RESOURCE CONSERVATION AND RECOVERY ACT FACILITY INVESTIGATION REPORT
ADDENDUM FOR ZONE I AND U S NAVY RESPONSES TO SOUTH CAROLINA
DEPARTMENT OF HEALTH AND ENVIRONMENTAL CONTROL COMMENTS CNC
CHARLESTON SC
9/5/2001
CH2M HILL

Zone I RFI Report Addendum and Responses to SCDHEC Comments

***Charleston Naval Complex
North Charleston, South Carolina***

Re: RFI Report Addendum – Zone I

SWMU 12 Laydown Yard & Oil Sludge Pit Investigation Area

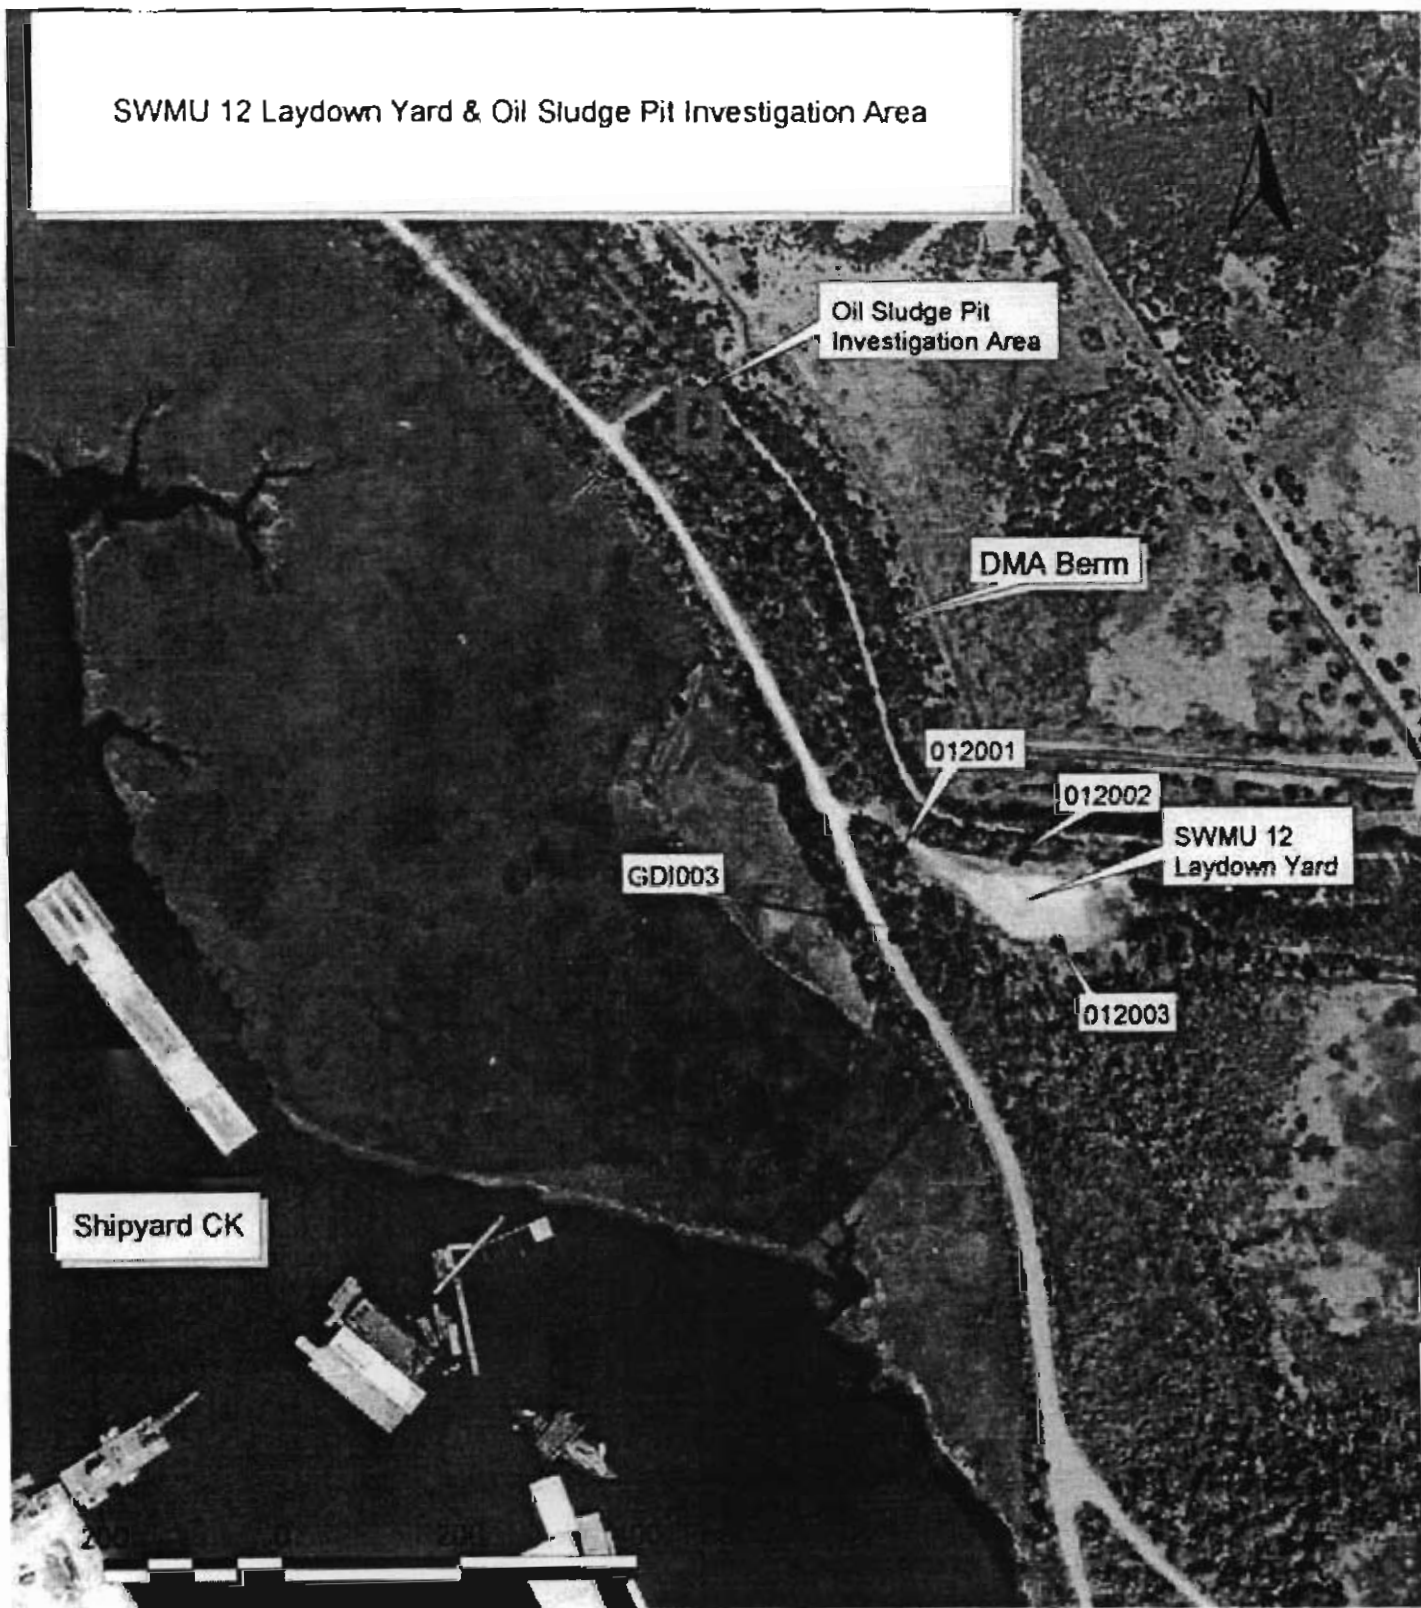
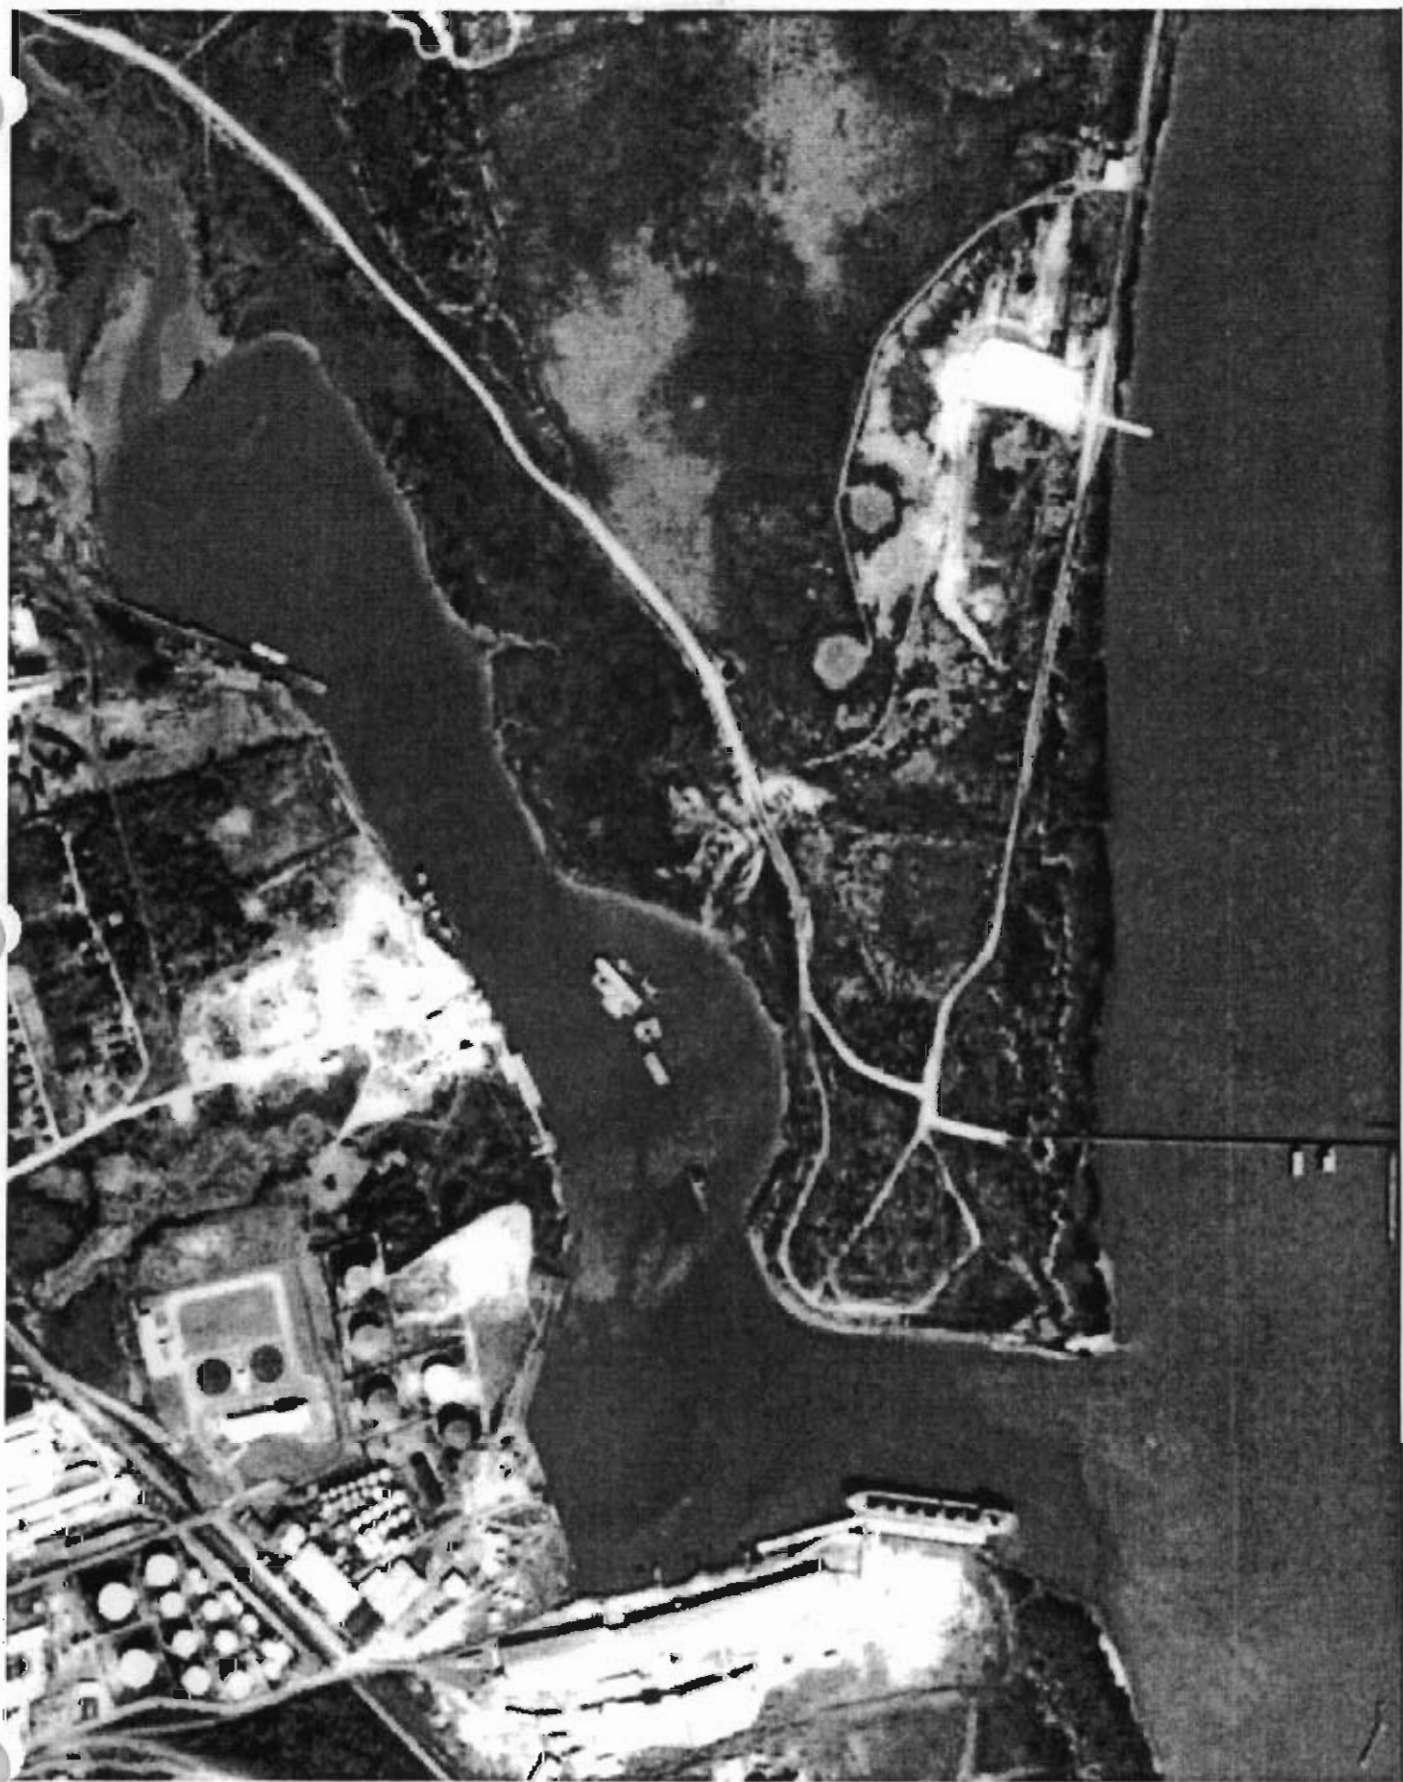
CH2M-Jones concurs with the response provided by EnSafe/Navy. However, SCDHEC has since provided an additional undated aerial photograph that shows a historical surface feature further northwest, along the same road, and has questioned whether the correct location was originally investigated for SWMU 12. Based on review of the existing database, it appears that sampling may have already been conducted in this area.

Based on research conducted in response to this comment and by obtaining the geographic coordinates relative to known features, CH2M-Jones has concluded that the feature in the vicinity of SWMU 12, cited by SCDHEC from an undated aerial photograph, does not warrant further investigation or evaluation. The area was initially investigated by a team from Environmental Science and Engineering in 1981 during the Initial Assessment Study (see Appendix A1). The field investigation did not turn up any evidence of residue from the pit. Geraghty and Miller also conducted an assessment for a confirmation study in 1982, again finding no evidence of concern in the subsurface soils or petroleum-related plumes, even though the Geraghty and Miller investigation specifically looked for potential soil and groundwater impacts (see Appendix A2).

Figure 1
AOC 679 Historical Record
Zone I RFI Report Addendum
Charleston Naval Complex Annex - Zone I

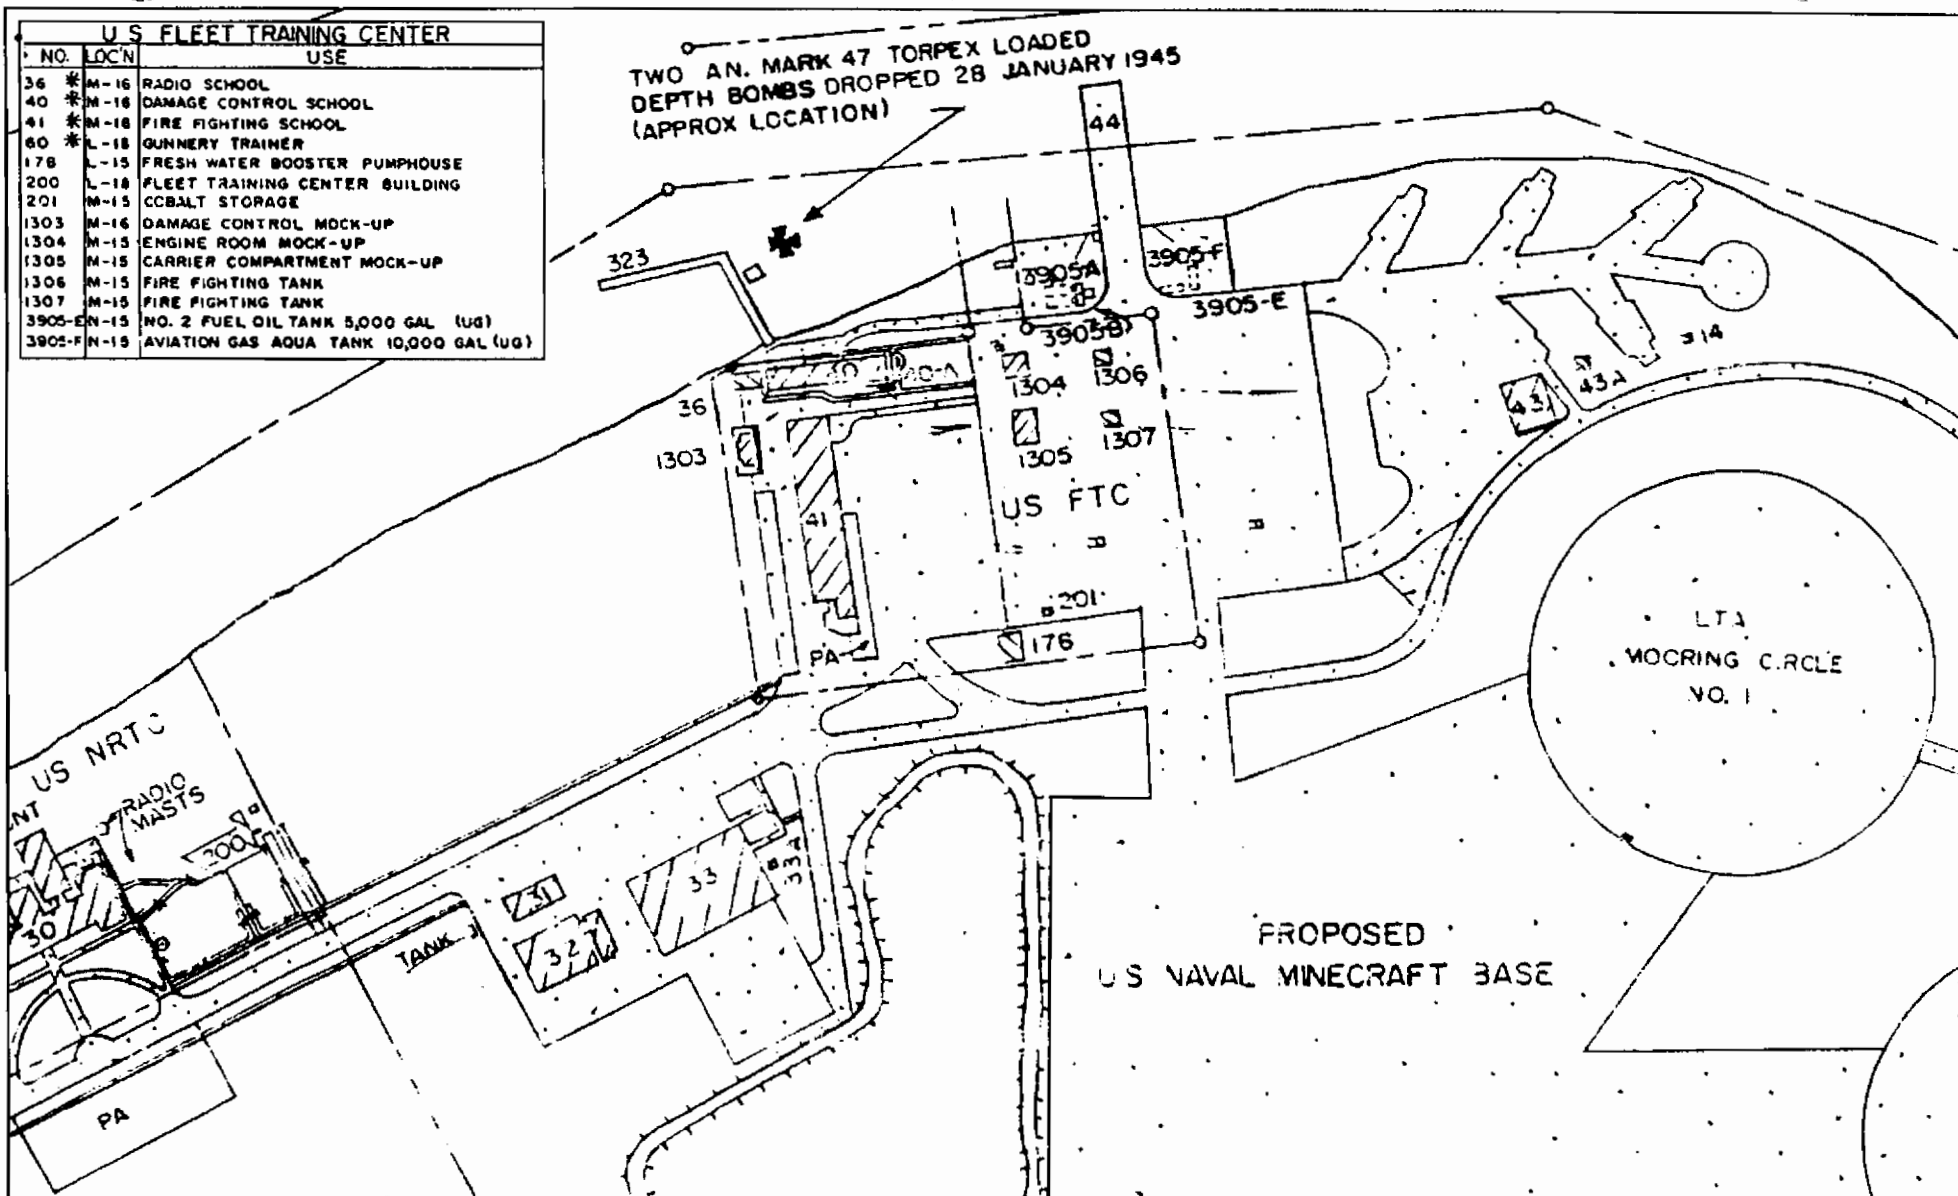
Comment 2. Comment number 1 : AOCs 678/679. Figure 10.4.1. Please revise the figure to accurately locate the wash rack area and identify the sampling locations with respect to this site. The Department does not agree with the response for not changing the figure.

¹ The Firefighter School is shown in historical data (Figure 2) to be located in Building 41 not Building 2-V as indicated in the Zone I RFI Report, Revision 0.
